**FINAL DRAINAGE REPORT
FOR
McCLINTOCK STATION FILING NO. 1A
(VOLLMER ROAD RV STORAGE)**

**January 2024
Project No. 25251.00**

PCD File No. PPR-2245

PROPOSED DRAINAGE MAP
 VOLLMER RV STORAGE
 JOB NO. 25251.00
 01/15/2024
 SHEET 1 OF 1

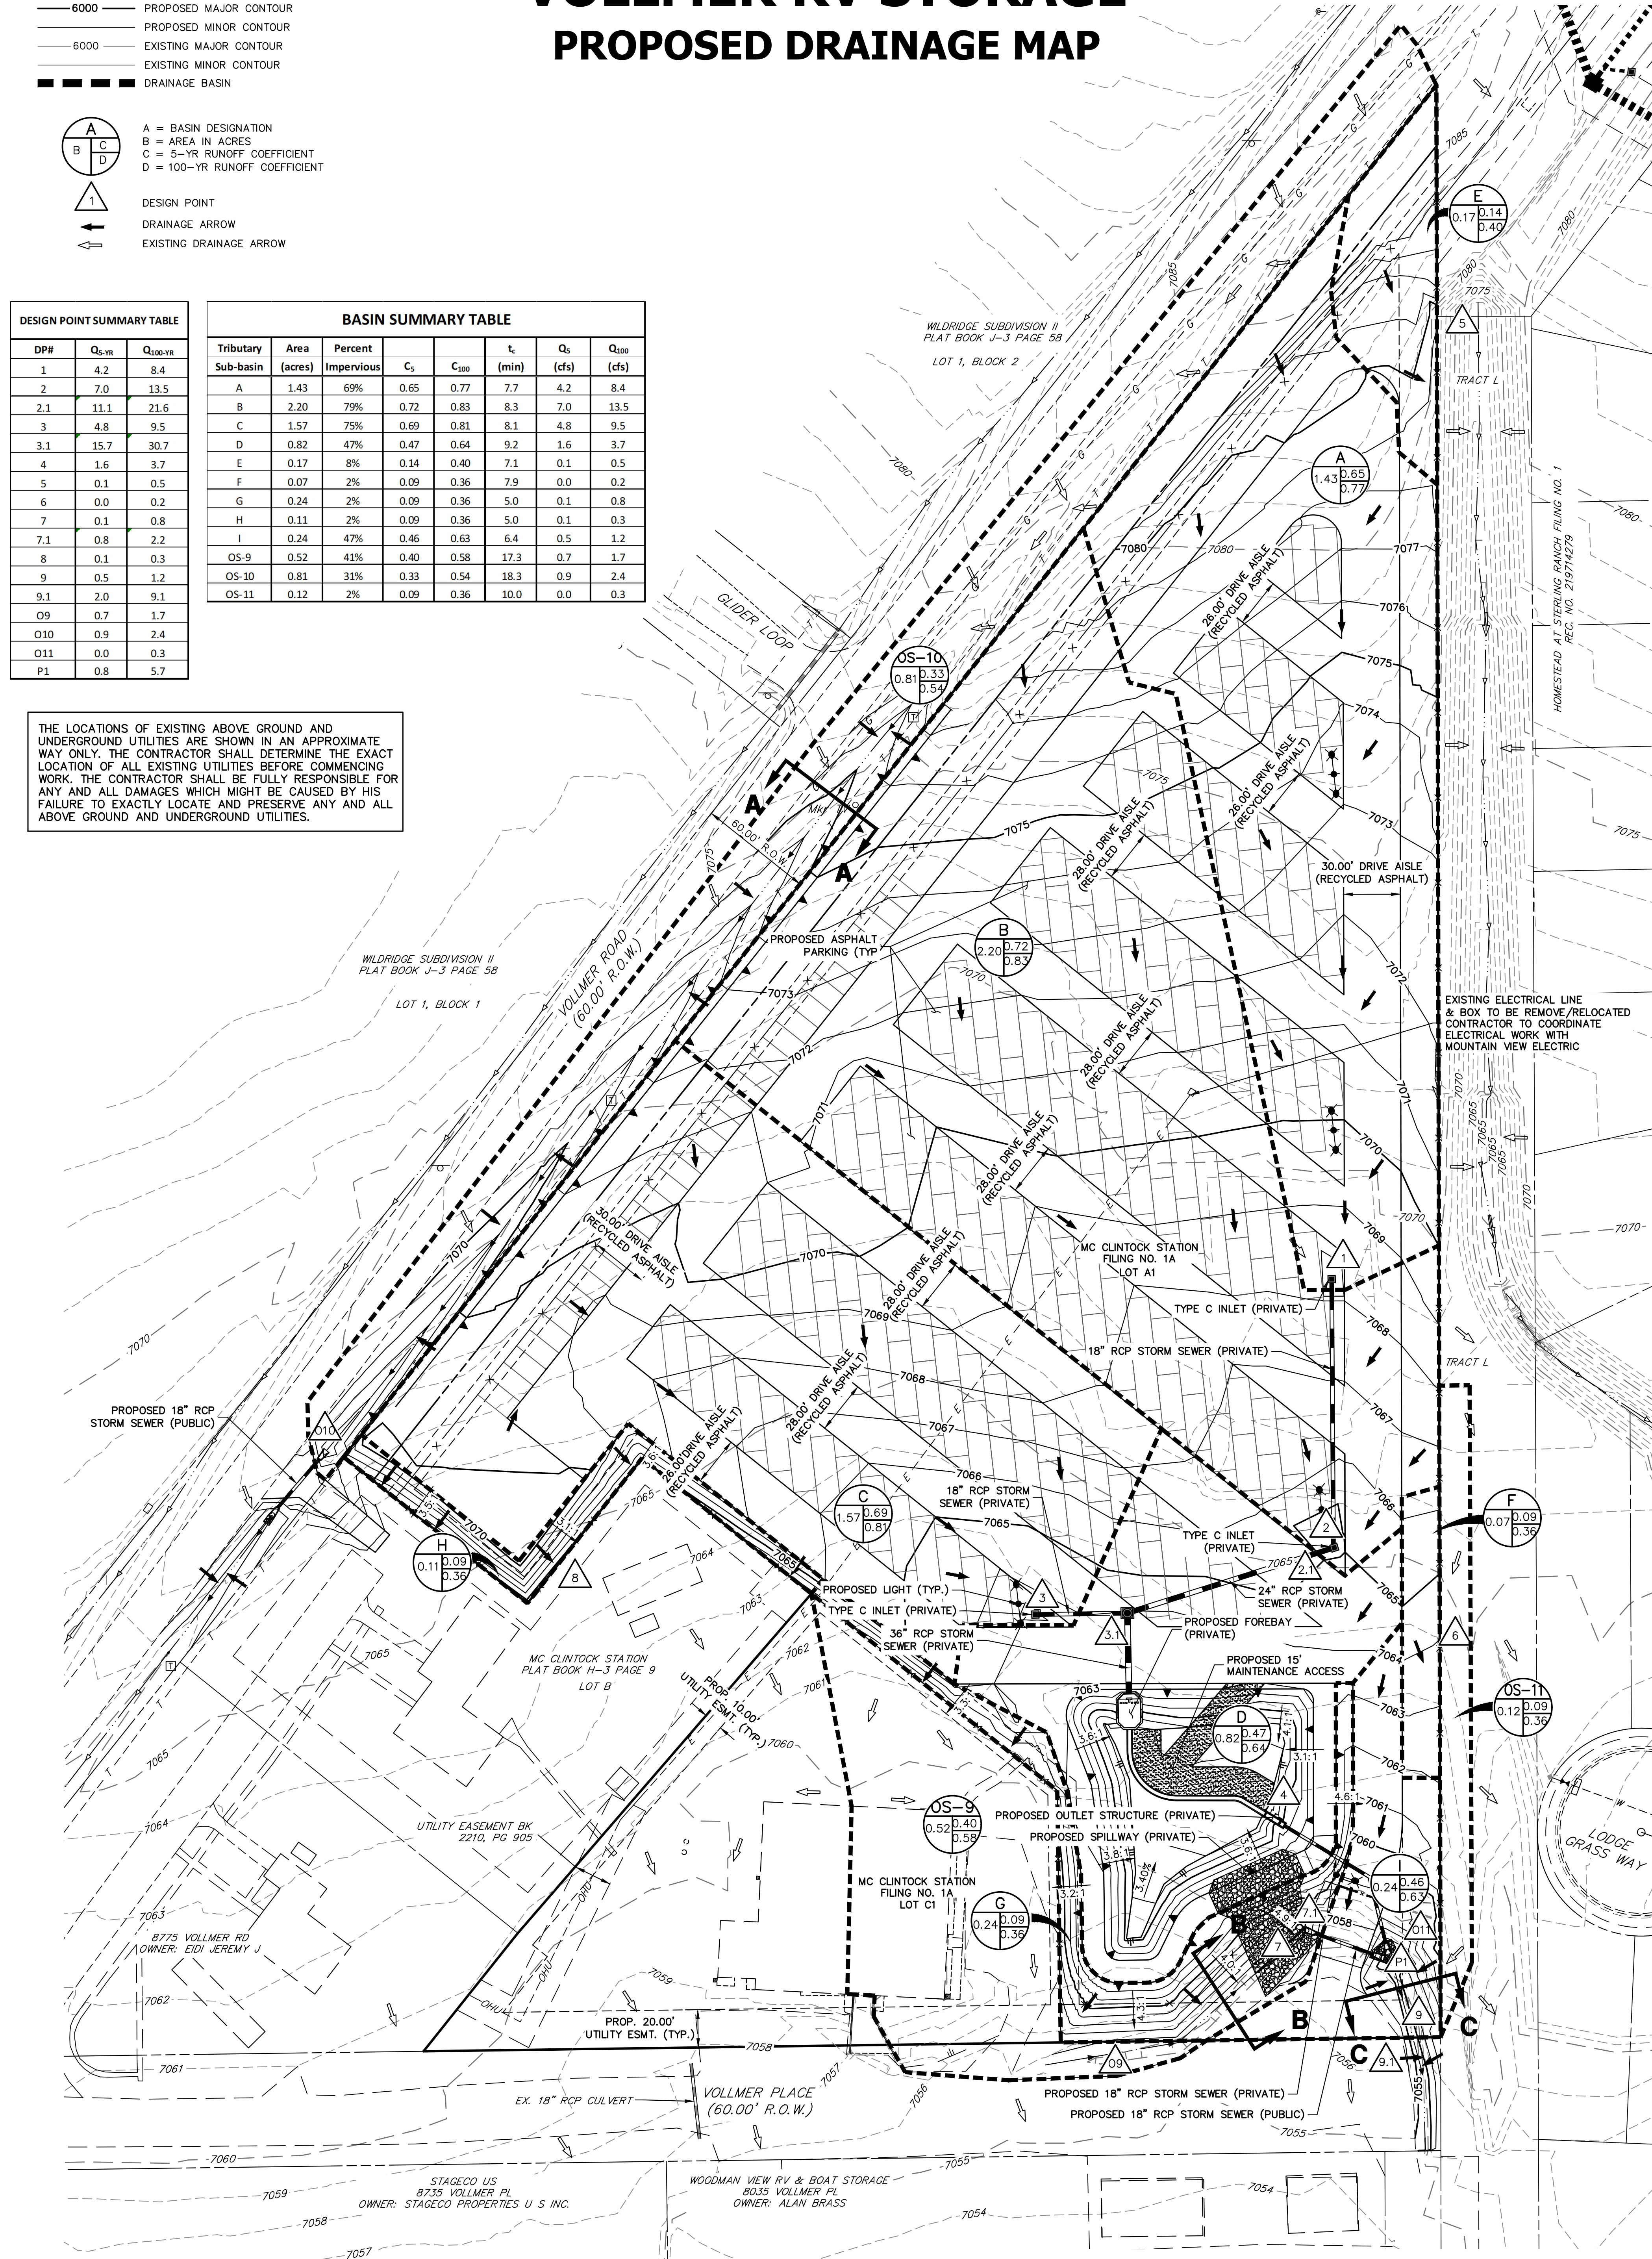
Basin flows still need to be combined with pond release rates. It appears at that point, flows exiting site (DP9.1) may be more than existing. Please revise statement accordingly.
